SUBJECT: Richmond County, Ellerbe Bypass and Ellerbe Connector (NC  
Extension) US 220; TIP Number R-2231B;  
Federal Aid Project Number NHF-45-1(49);  
State Work Order Number 8.T550803

Attached are the modifications of the US Army Corps of Engineers Individual 404 permit and the DWQ 401 general Water Quality Certification.

Subject: Action ID No. 199400590, TIP No. R-2231, Ellerbe Bypass, Richmond Counties, North Carolina.

**R-2231B, permit drawing sheet 28 of 43, Station 27+00 - 28+75, Site 6**

**SITE 6  
IMPOUNDMENT  
W // STEP POOLS**

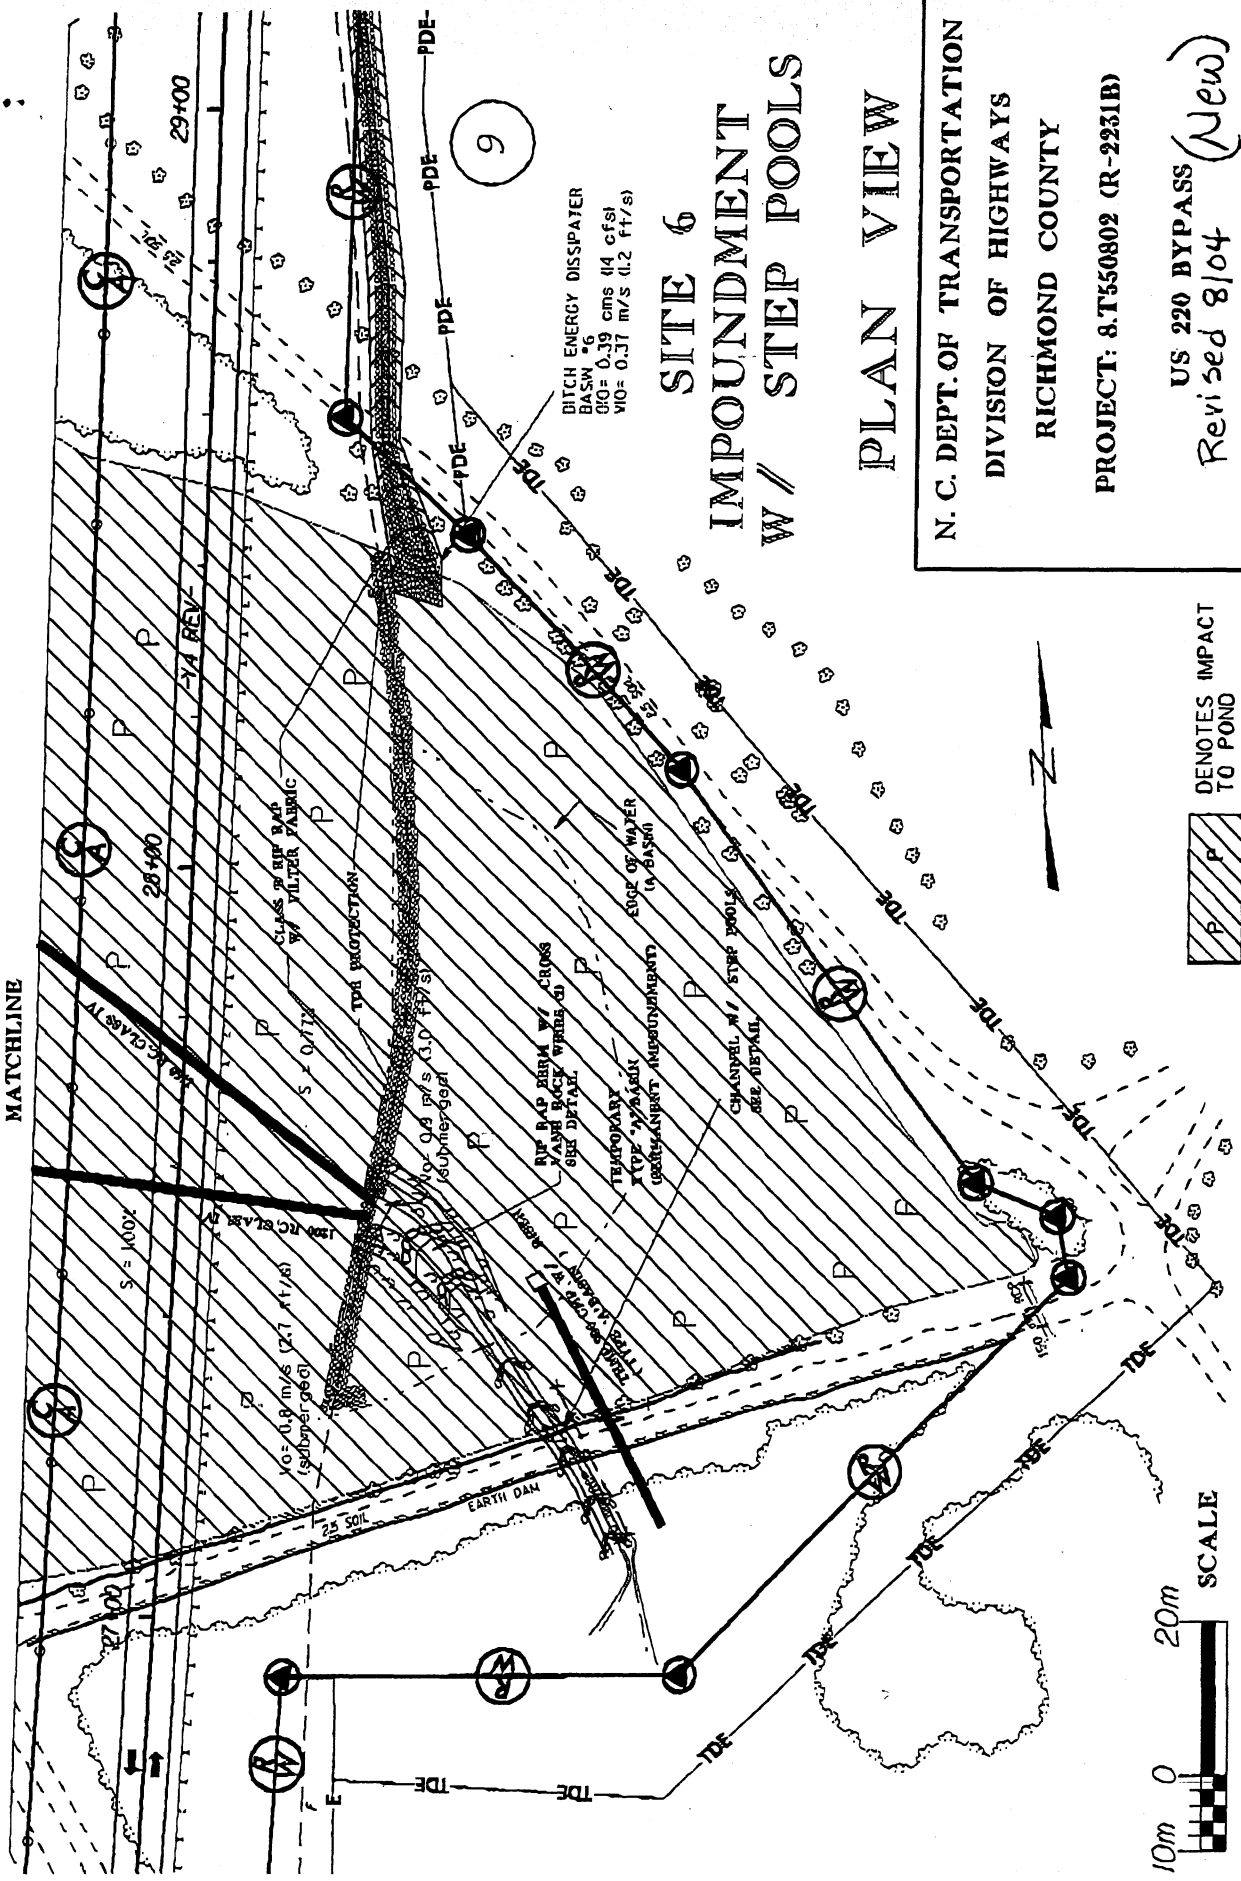
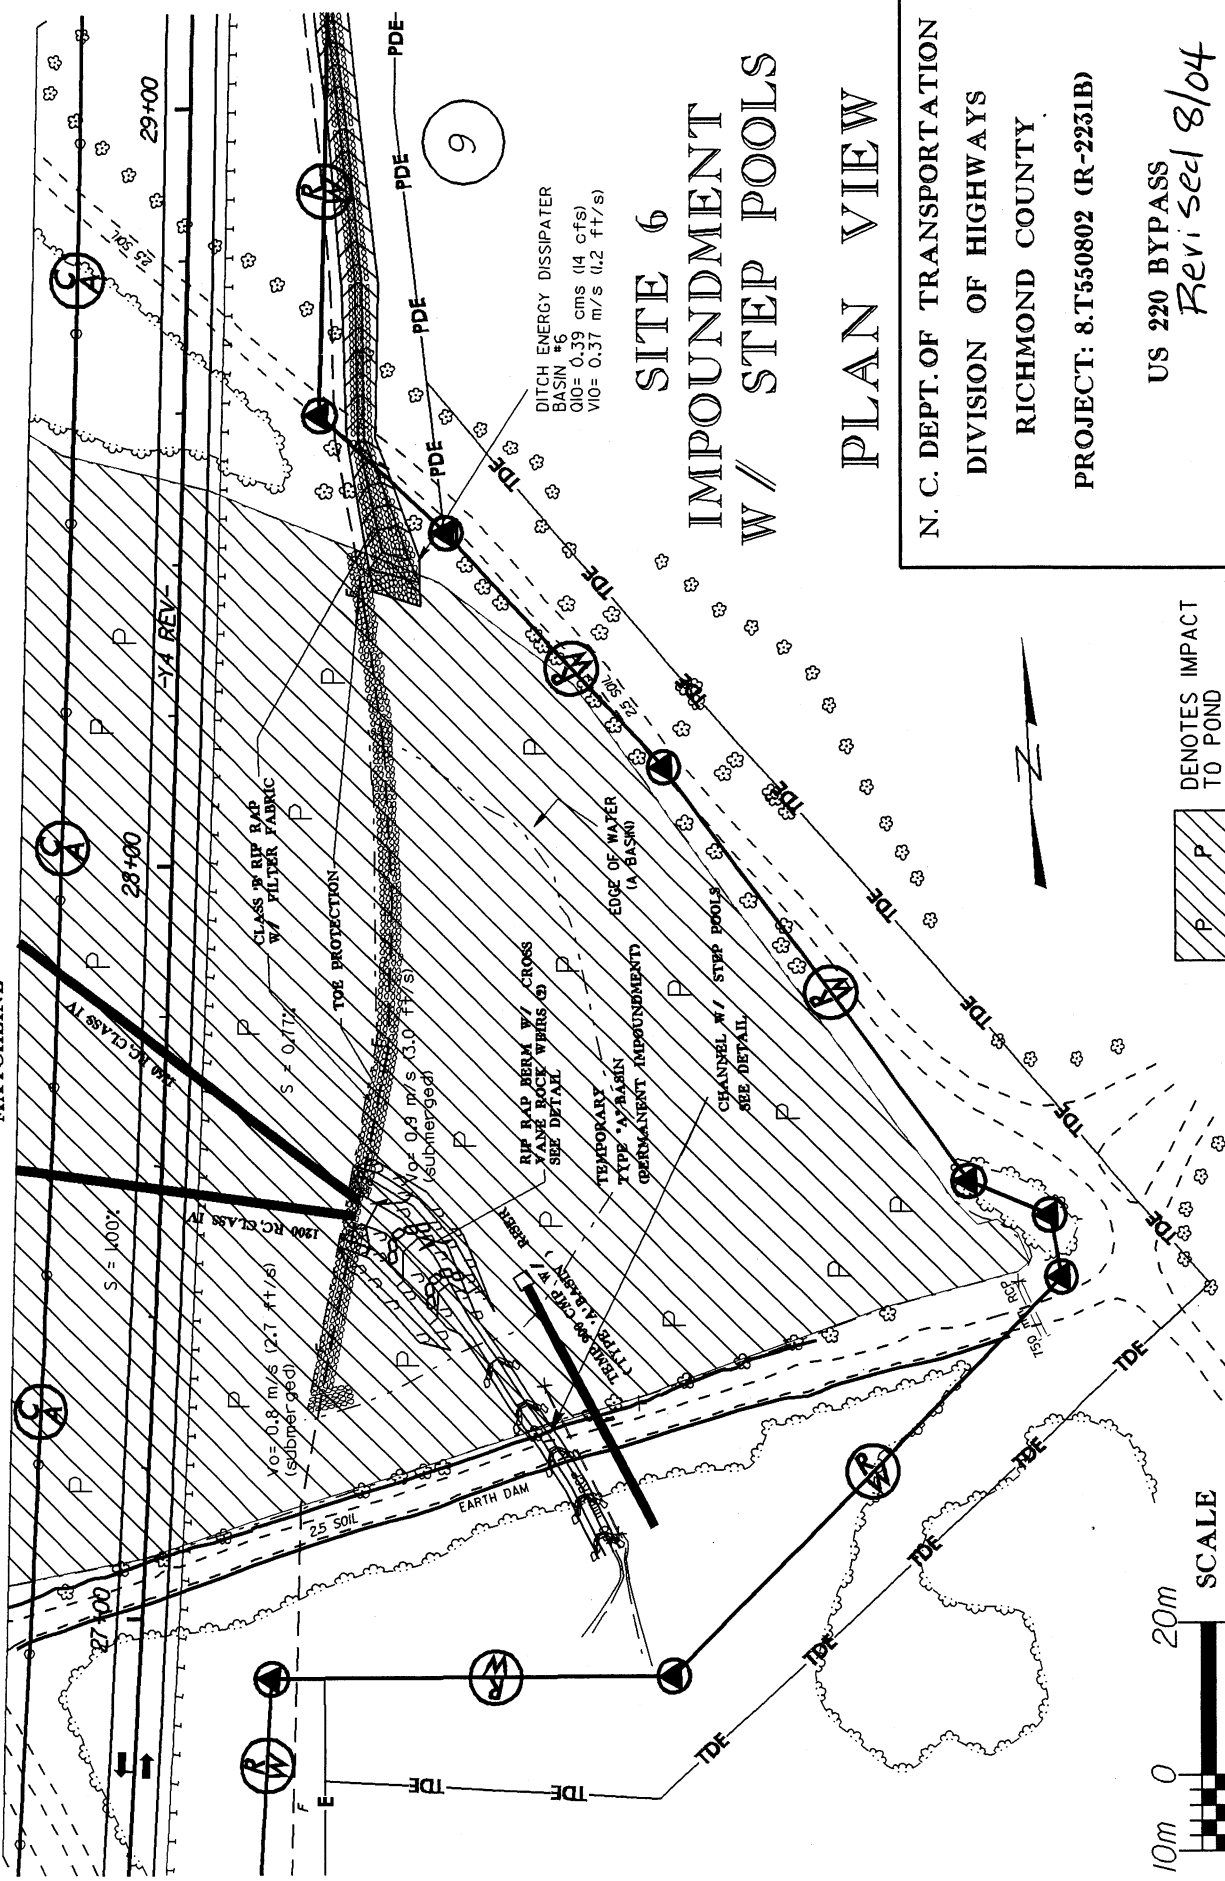
The referenced modified Section 404 permit authorized the modification to the east side of the Myrick Pond mitigation site. However, NCDENR, as a condition of their revised Section 401 Certification has requested that the redesign incorporate an additional structure within the impoundment area. The structure requested by NCDENR would be a rip-rap berm with cross vane rock wiers located at the ends of the road culverts and extending to the stepped outfall structure previously authorized by the August 26, 2004 modification.

Eliminate the stream relocation design below the proposed roadway. A step-pool channel is proposed through the dam to stabilize this site. See attached hydraulic plans and supporting data.

**Mitigation change: elimination of 249 linear feet of Natural Stream Design**

I have determined that the proposed project modification described above is not contrary to the public interest and therefore, the DA permit is hereby modified to include authorization for the modification listed above and as shown on the revised permit drawings (enclosed).

# RIP RAP BERM AND CROSS VANE ROCK WEIR DETAIL

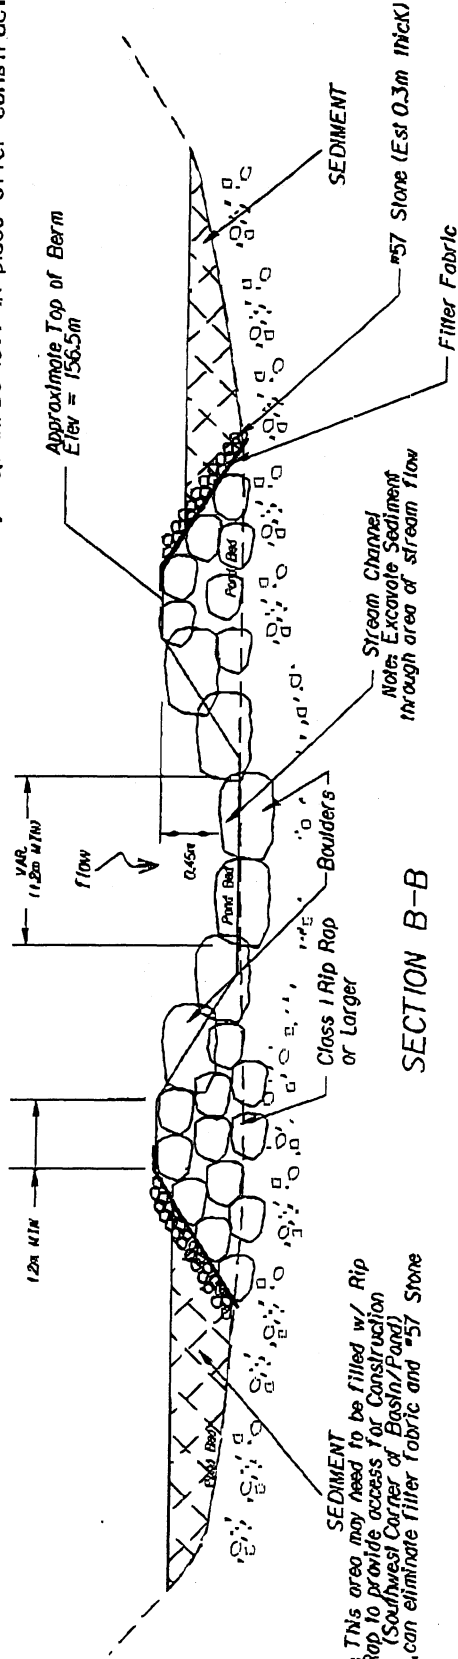
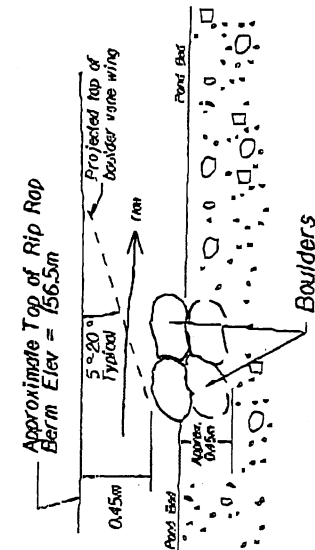
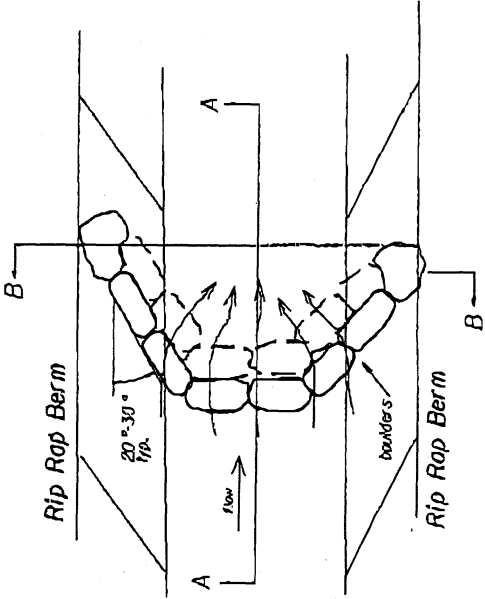
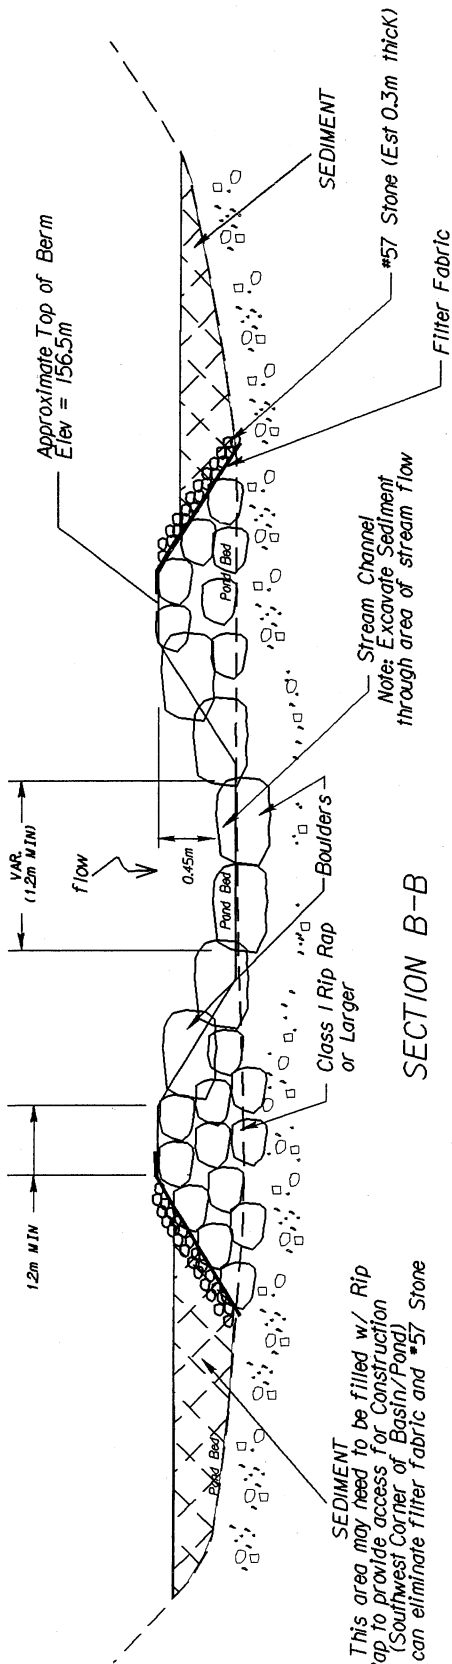
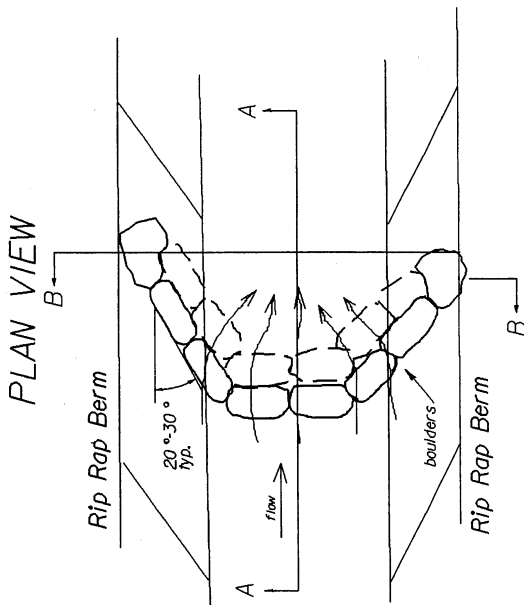
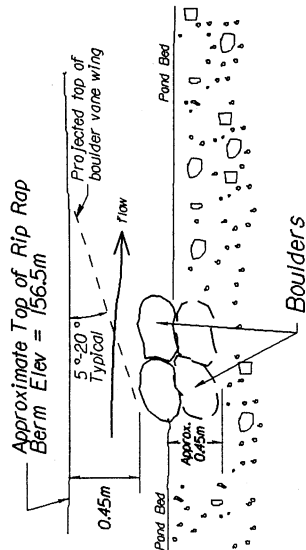
Rock vanes shall be constructed and placed according to the plan sheets titled Site 6 Impoundment w/ Step Pools, Rip Rap Berm and Cross Vane Rock Weir Detail Sheet developed by NCDOT Hydraulics Unit and received by the DWQ Transportation Permitting Unit on September 1, 2004.

- d. Rock vanes shall be constructed and placed according to the plan sheets titled *Site 6 Impoundment w/ Step Pools, Rip Rap Berm and Cross Vane Rock Weir Detail Sheet* received by the Transportation Permitting Unit on September 1, 2004.
